M E M O R A N D U M

Subject: Chatterley Whitfield Colliery

Proposed alteration to Middle Pit Bottom Layout - Drg.No.1533/50

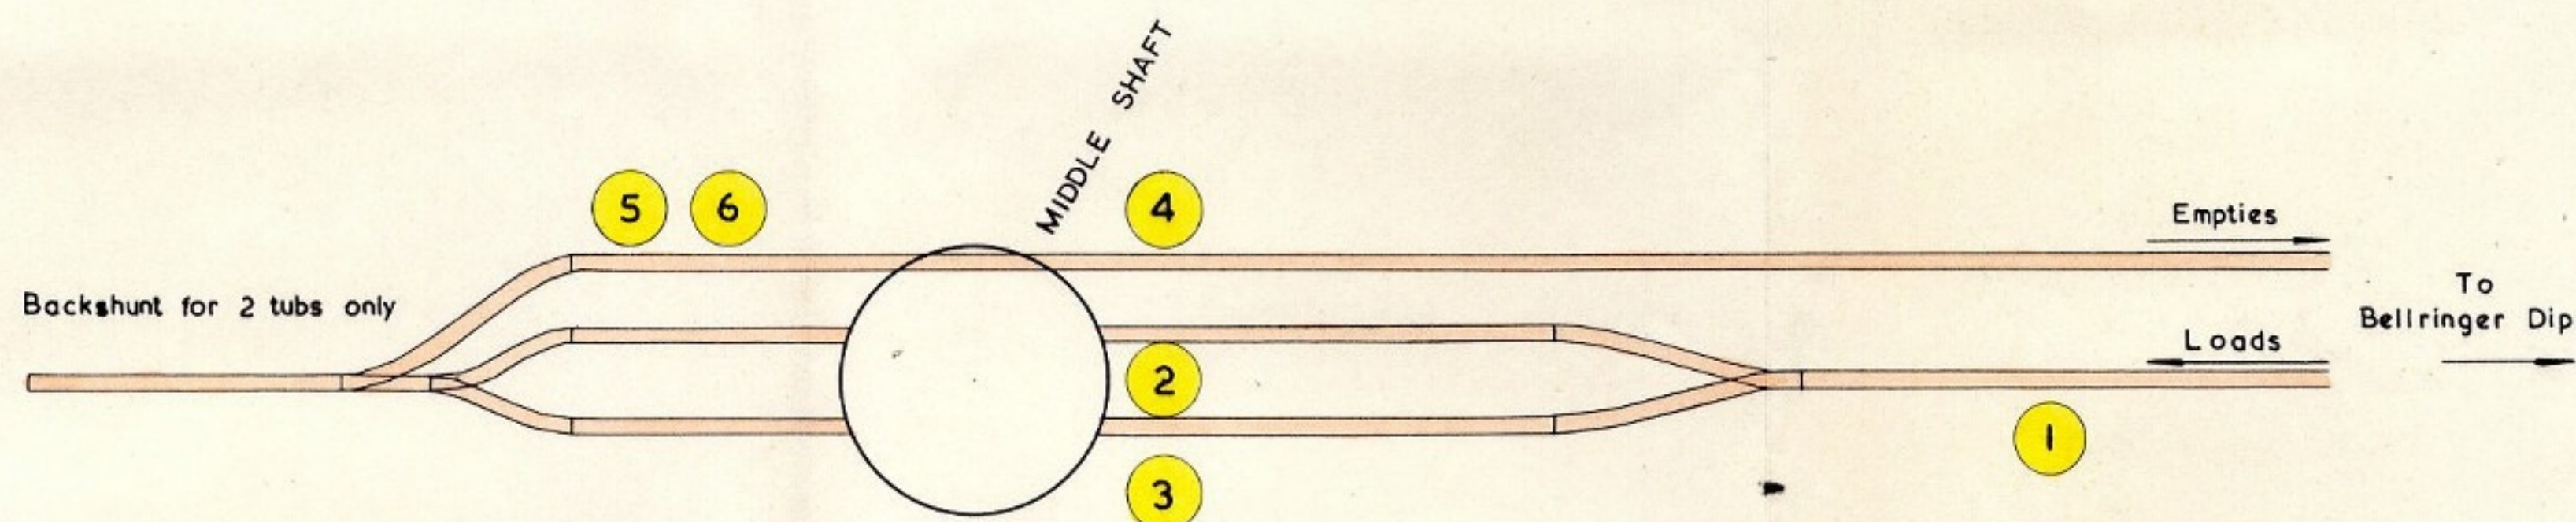
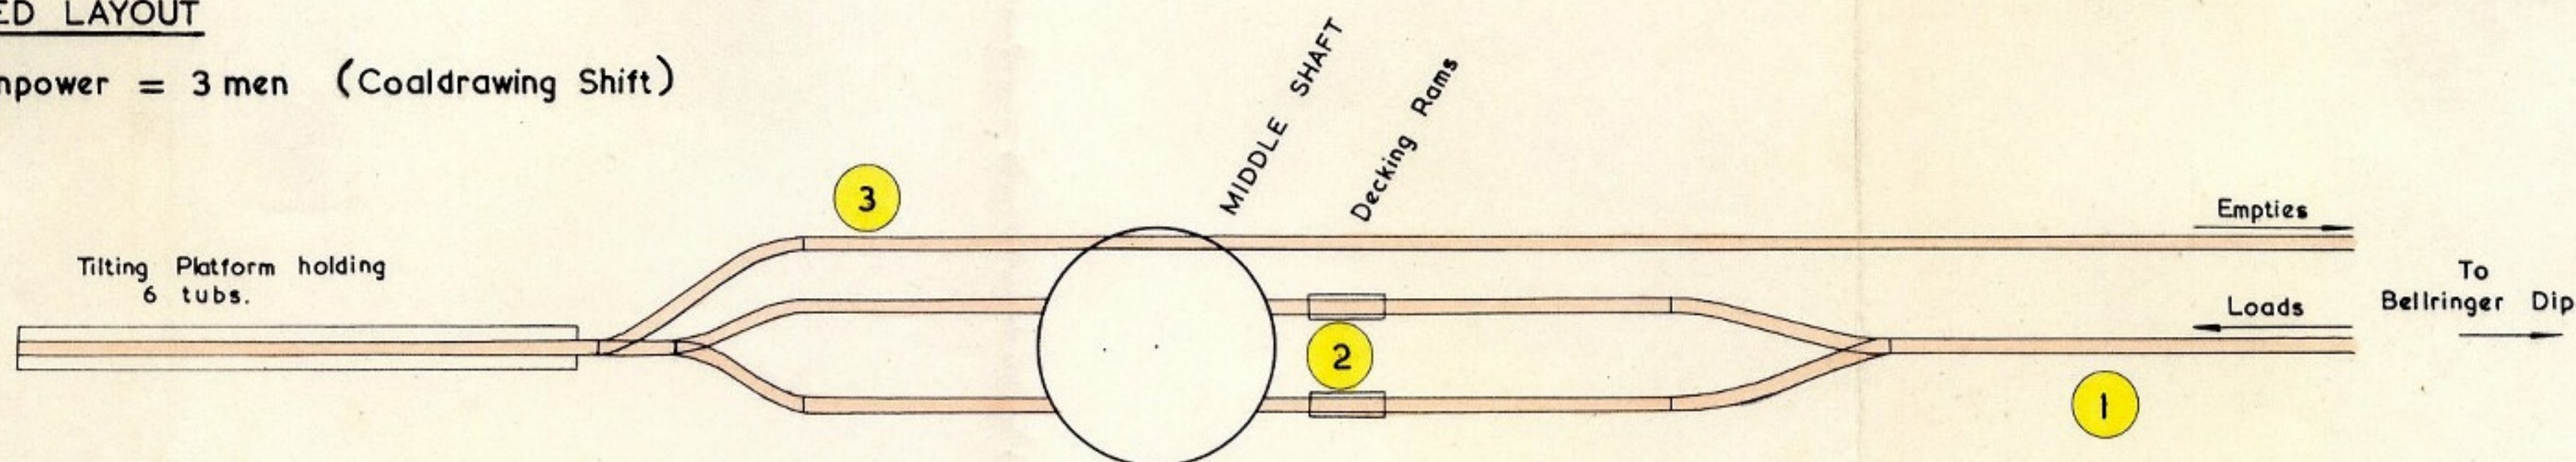
Please find enclosed one copy of a sketch plan shewing the proposed alteration to Middle Pit Bottom track layout.

Total Manpower = 6 men (Coaldrawing Shift)

- ① Uncoupling and loads splitting.
- ② Onsetter.
- ③ Pit Bottom General Assistant.
- ④ Assistant to Onsetter.
- ⑤ Empties Control, coupling and clipping-on.
- ⑥ Empties Control, coupling and clipping-on.

Total Manpower = 3 men (Coaldrawing Shift)

- ① Uncoupling and loads splitting.
- ② Onsetter.
- ③ Tilting platform operator, coupling and clipping-on.
